ZONING CHANGE REVIEW SHEET

CASE: C814-2024-0001 (500 South Congress PUD) DISTRICT: 9

ZONING FROM: CS-1-NP, CS-1-V-NP TO: PUD-NP

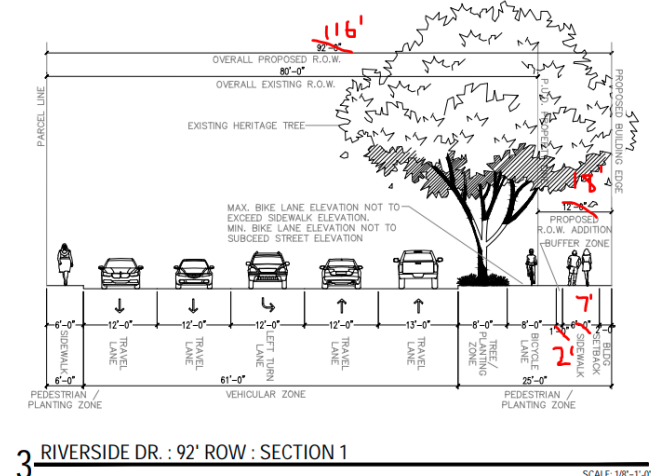
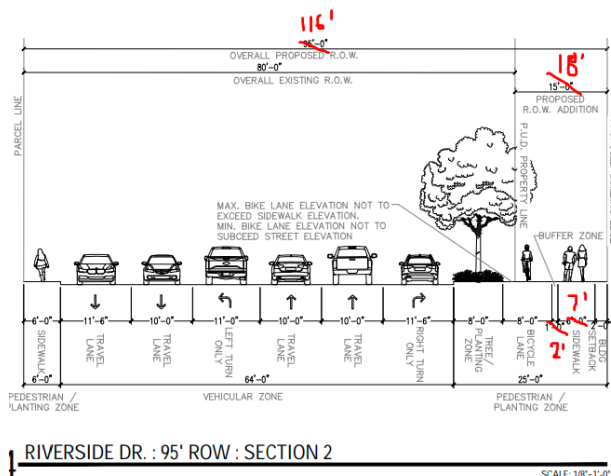
- ATD 2. All PUDs must provide for appropriate transportation and mass transit connections to areas adjacent to the PUD district and mitigation of adverse cumulative transportation impacts with sidewalks, trails, and roadways. Detailed comments will be provided through the traffic impact analysis (2.3.1.I).

U1/2/3: Comment pending.

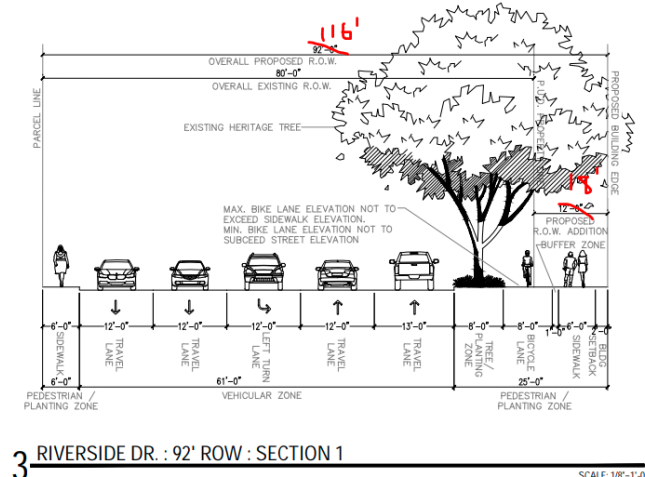
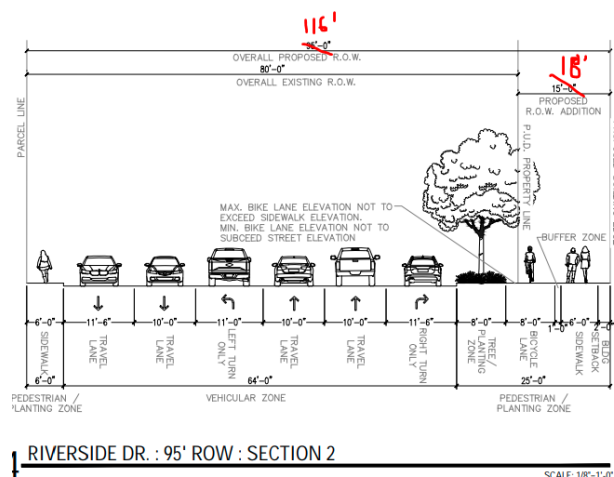
ATD 16. ASMP requires 116' of right-of-way for W. Riverside Drive. 58' of right-of-way for W. Riverside Drive should be dedicated from the centerline either at platting or with site plan.

U1: Comment pending. The PUD's street section exhibits should reflect ASMP requirement of 116'. Please indicate the centerline and 58' of ROW from that centerline.

U2: ASMP waiver request is approved; however, please revise diagrams to note "Proposed Permanent Access Easement" rather than "sidewalk" easement. TPW recommends removing the diagrams showing existing conditions for simplicity and continuity for future reviews.

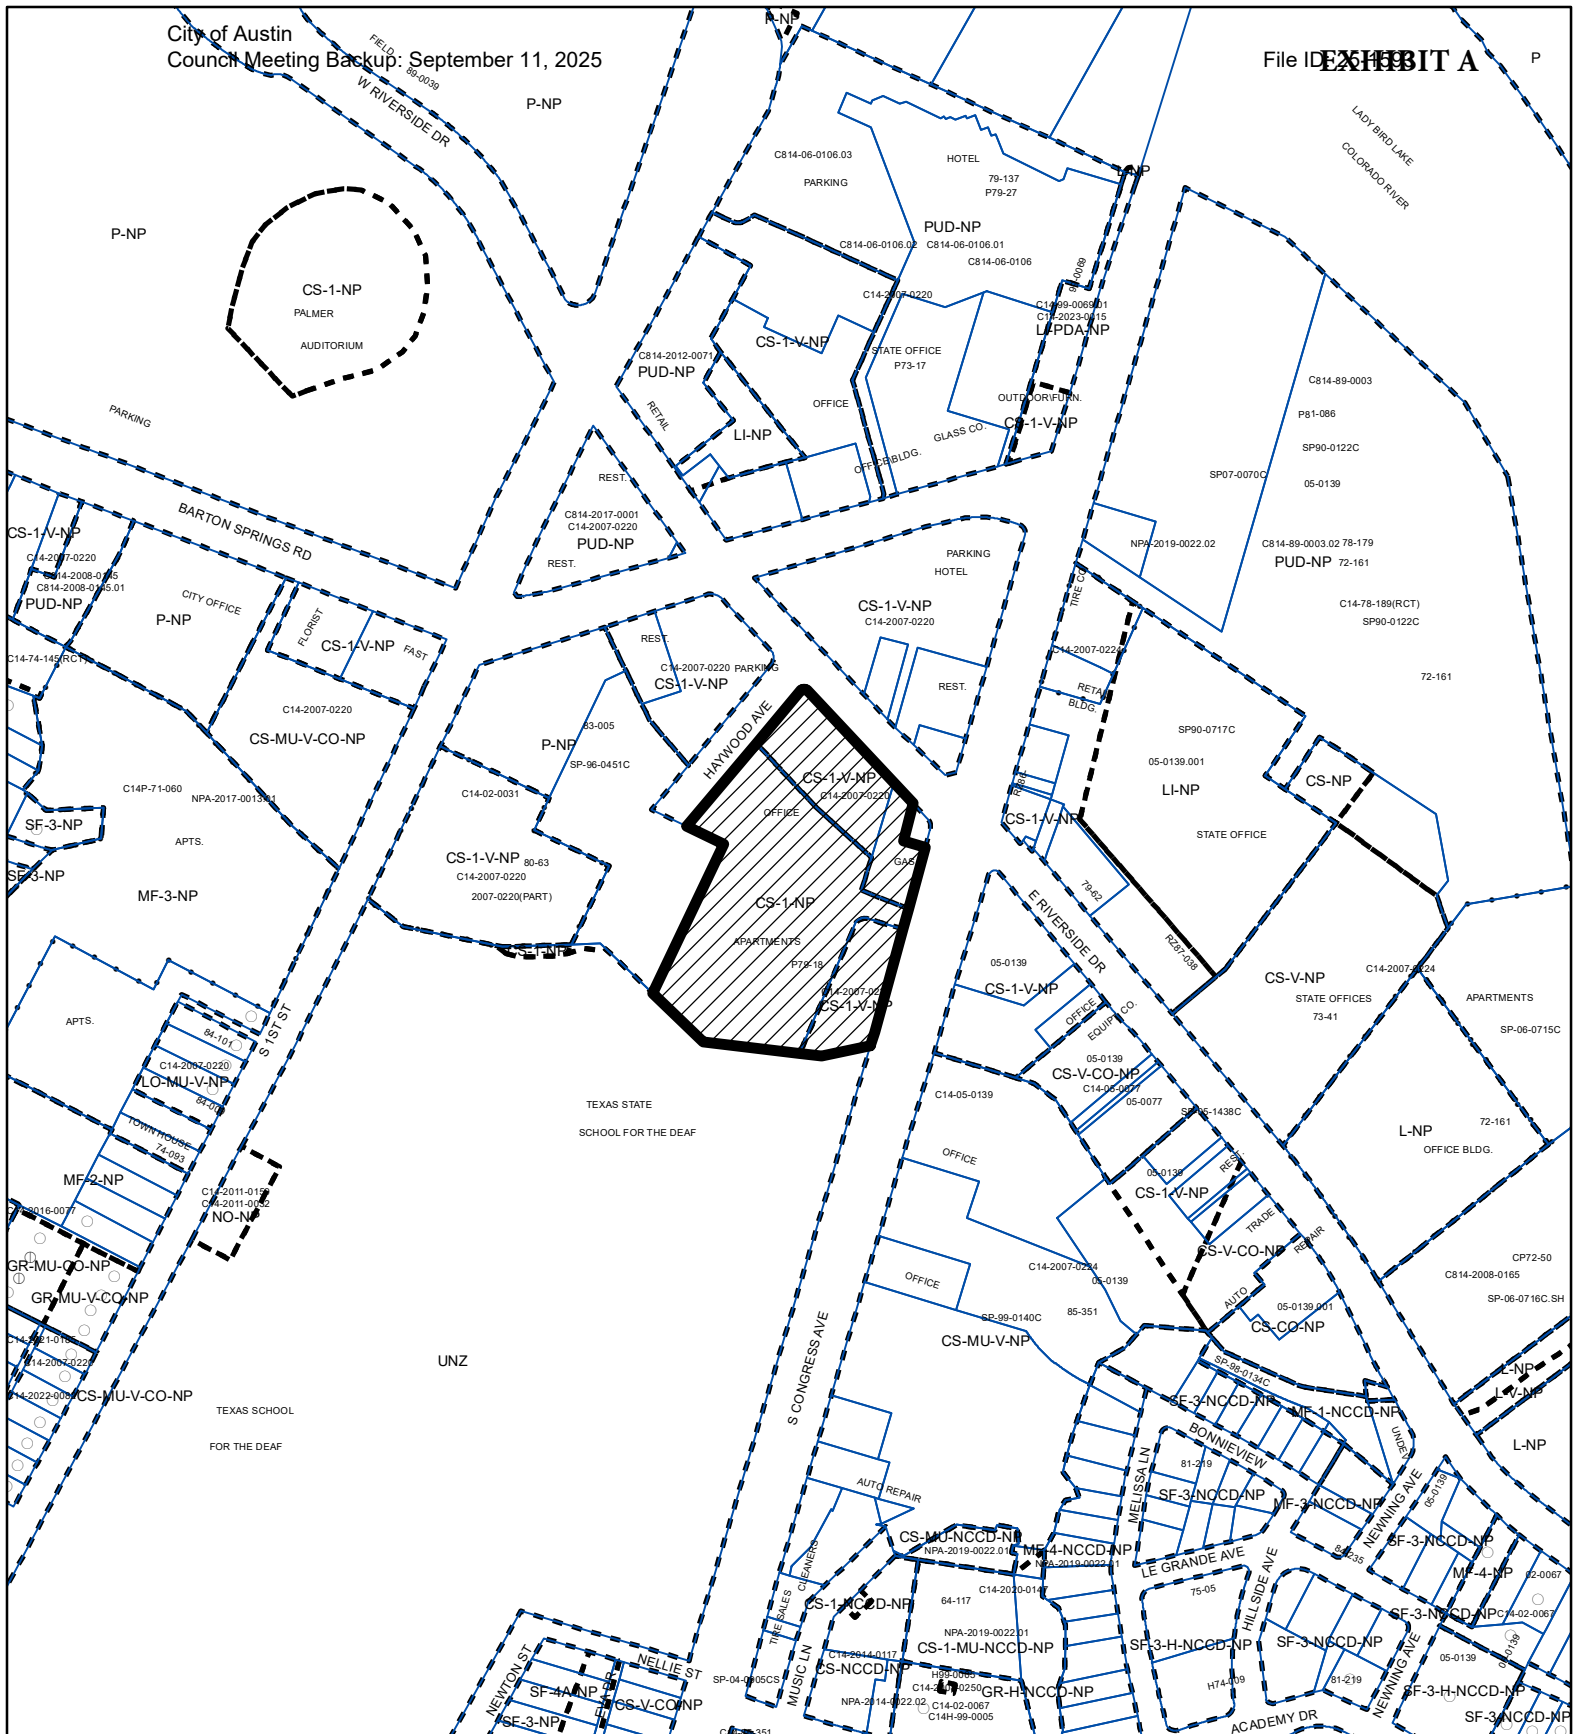
WB3. Update0. For the floodplain restoration requirements, the plan will need to use both Zone 2 and Zone 3 (Zone 2 floodplain in CWQZ, Zone 3 active channel) FAFH for the site.

U1: Comment pending *{Review of FAFH pending.}*

U2: Comment pending. *{Applicant submitted a final Zone 2 and Zone 3 FAFH. To offset the impacts of the code modification and provide a superior development, add the following requirement for riparian restoration to the land use notes: Riparian Restoration: This section applies along East Bouldin Creek*

sheet
L.04

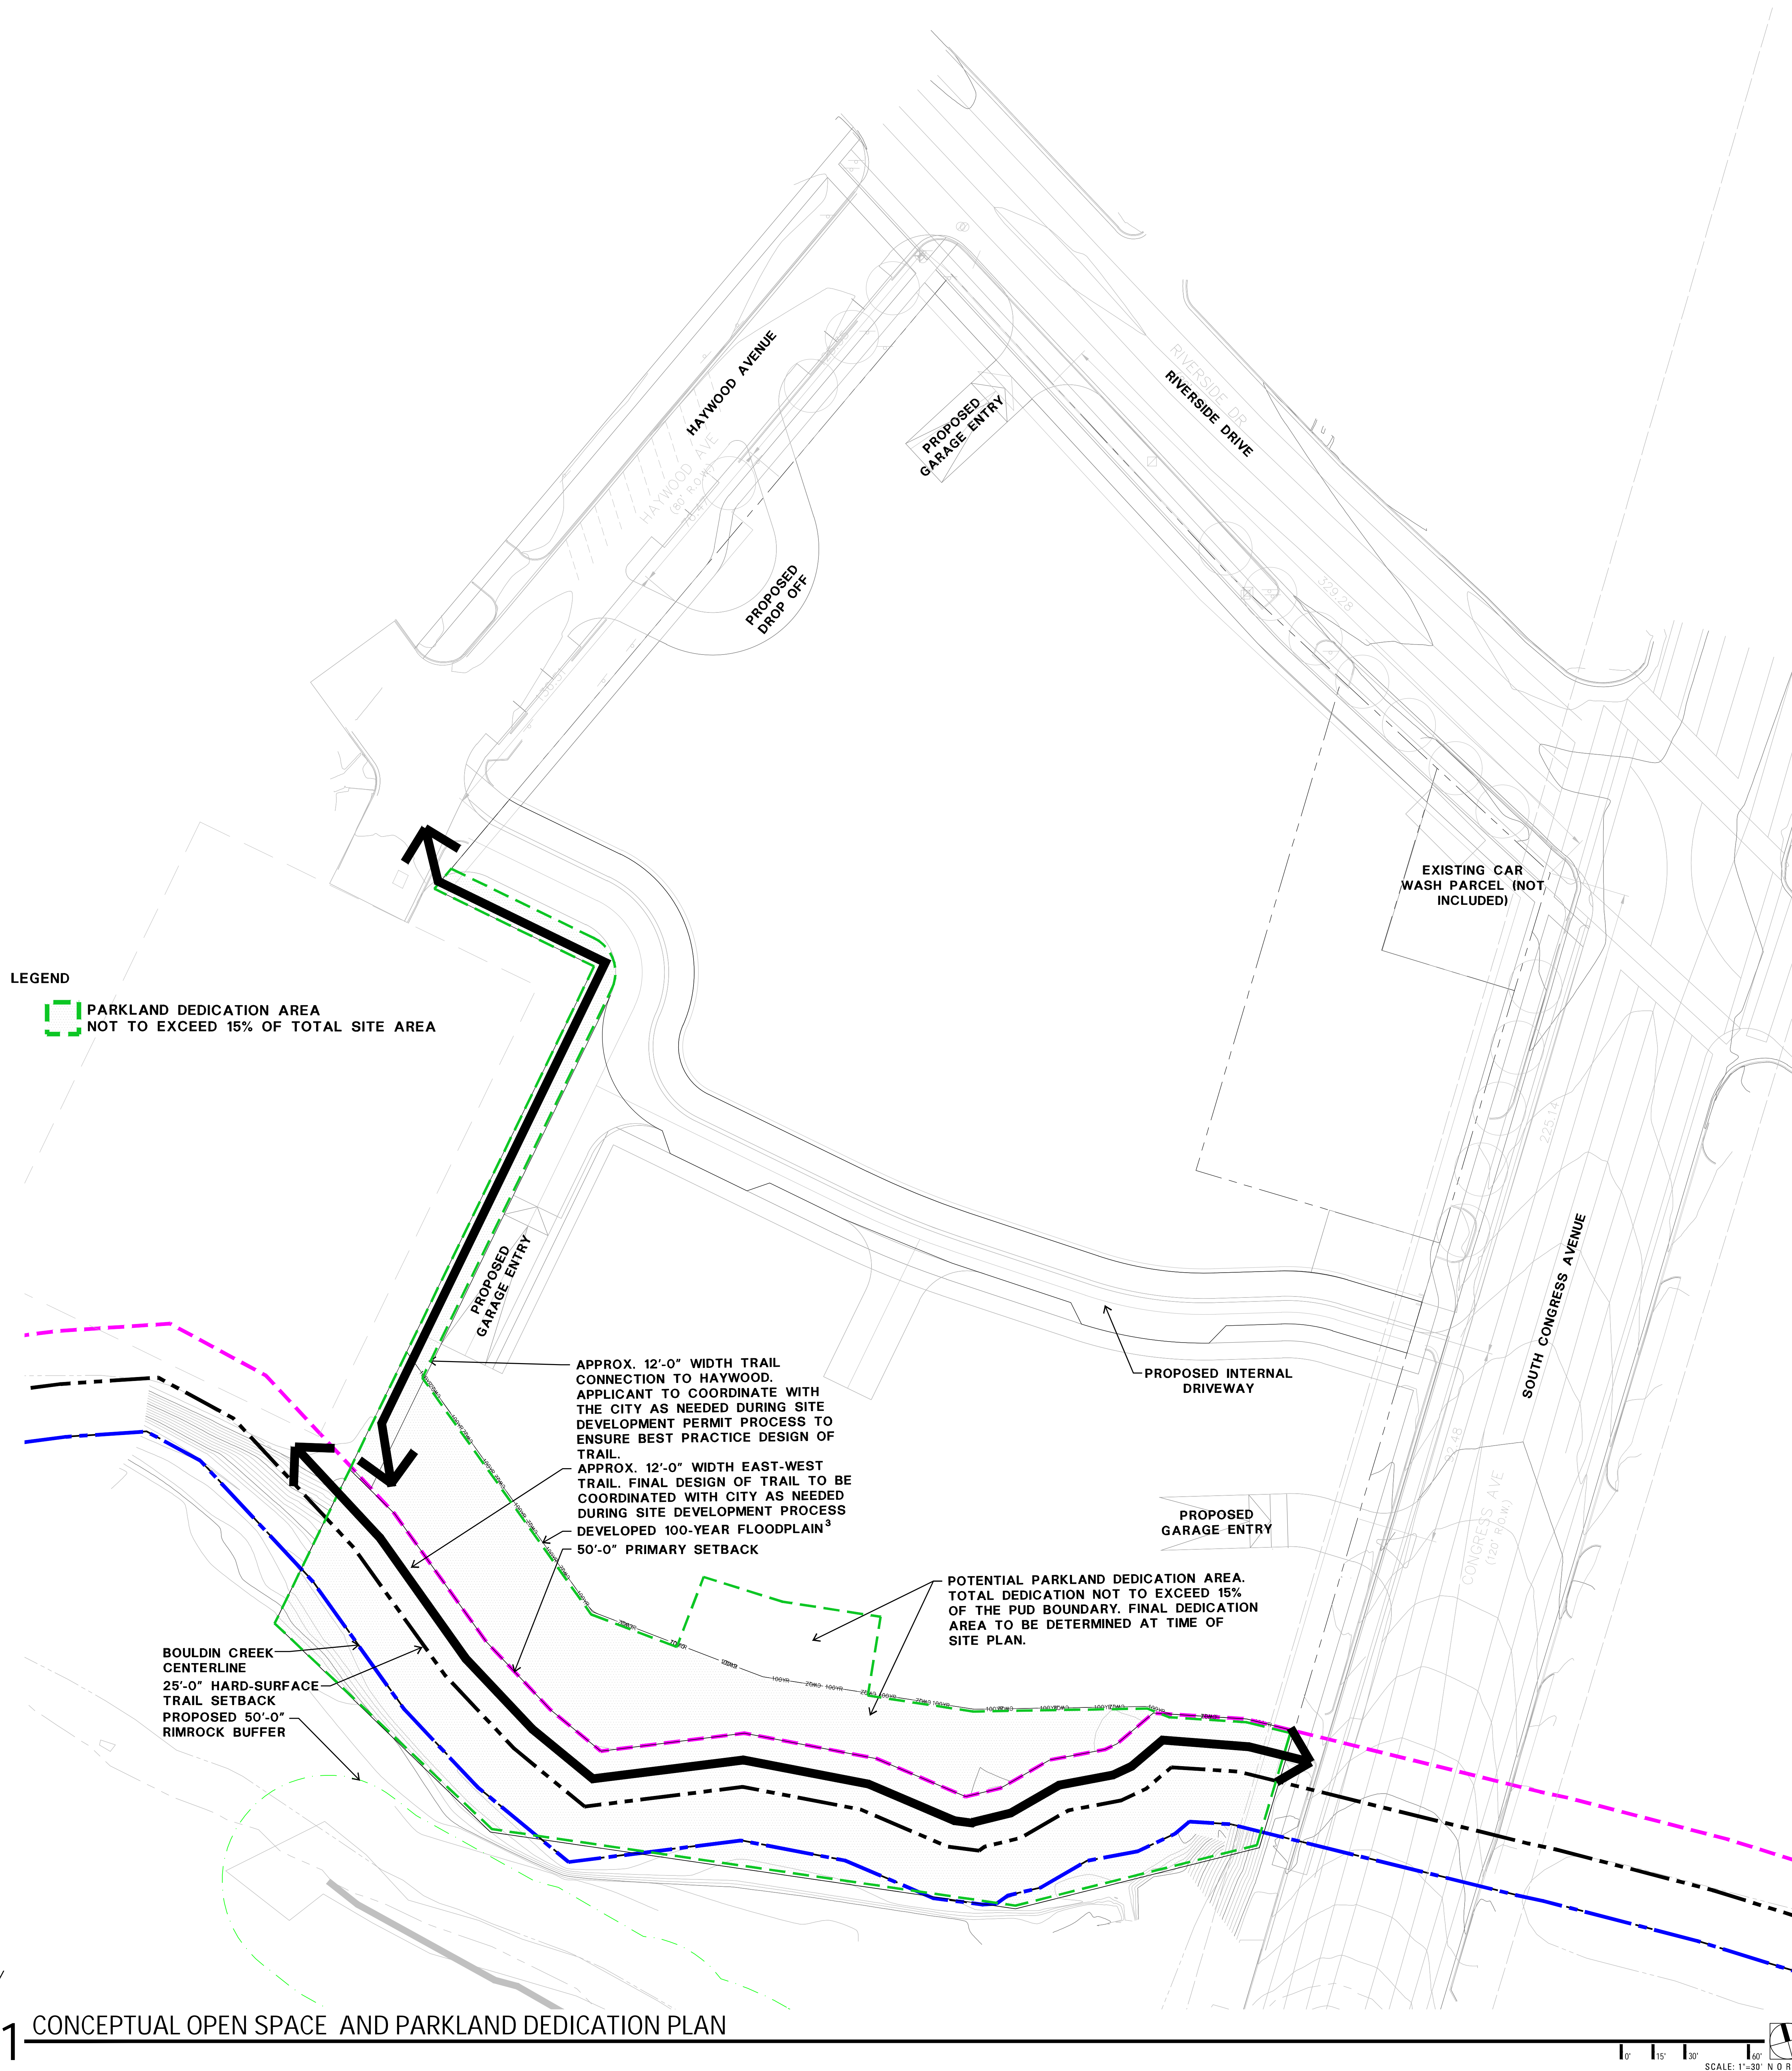
PUD EXHIBITS 2: Conceptual open space plan (sh. L.04)

EV 5 Show the 25-foot minimum setback from the creek centerline for hard-surfaced trails in an Urban watershed. [LDC 25-8-261(B)(3)(d)]

EV 6 Call out or label the maximum width of the proposed trail. Current code limits a hard surfaced trail in the CWQZ to “12 feet in width plus one-foot compacted sub-grade shoulders, unless a wider trail is designated in a Council-adopted plan.” [LDC 25-8-261(B)(3)(c)]

U1 **PENDING.** I do not see the maximum width stated on the exhibit. Add it to the callout for the trail/boardwalk on sh. 5.
